Access Compliance Report Public Rights-of-Way (Curb Ramps)

Main Street: STANTON_AVE		Cross Street: FAIRHOPE_DR		Location:	SW
ADA ID: RPAT210921124246	Ramp Type: Type 4 - Parallel	Initial Pass/Fail: Fail	Overall Compliance: No	Severity Score:	15

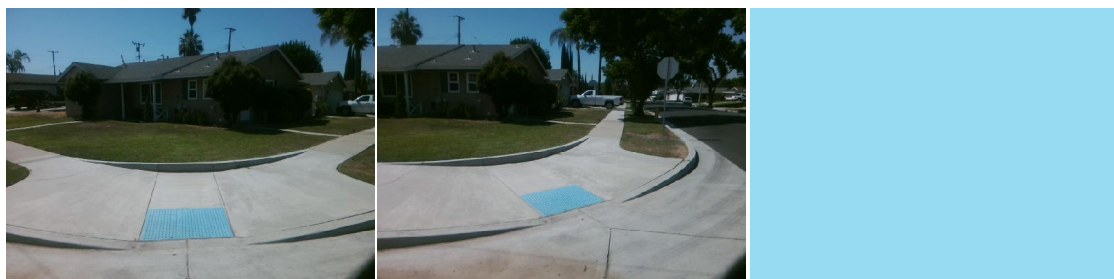
Compliance	Description	Data	Compliance	Description	Data
N/A	Ramp Length LT (in)	109	N/A	Ramp Length RT (in)	111
Yes	Ramp Width LT (in)	124	Yes	Ramp Width RT (in)	123
Yes	Ramp Run Slope LT (%)	6	No	Ramp Run Slope RT (%)	9.3
Yes	Ramp Cross Slope LT (%)	1	Yes	Ramp Cross Slope RT (%)	0.5
N/A	Landing Present	N/A	N/A	DWS Provided	N/A
N/A	Landing Length (in)	N/A	N/A	DWS Contrast	N/A
N/A	Landing Width (in)	N/A	N/A	DWS Length (in)	N/A
N/A	Landing Run Slope (%)	N/A	N/A	DWS Full Width	N/A
N/A	Landing Cross Slope (%)	N/A		DWS Offset Type	N/A
N/A	Landing Movement Obstructed?	N/A	N/A	DWS Offset Left (in)	N/A
	Landing Movement Type	N/A	N/A	DWS Offset Right (in)	N/A
N/A	Landing Shared	N/A			
N/A	Clear Space	Yes			
N/A	Clear Space To Crosswalk (in)	N/A			
N/A	Marked Crosswalk 1	No	N/A	Marked Crosswalk 2	No
	Crossing 1 Direction	E		Crossing 2 Direction	N
	Marked Crosswalk 1 Width (in)	N/A		Marked Crosswalk 2 Width (in)	N/A

Remove & Replace Curb Ramp With Two New Directional Ramps or Equivalent.

R304.3.2, STD 1115
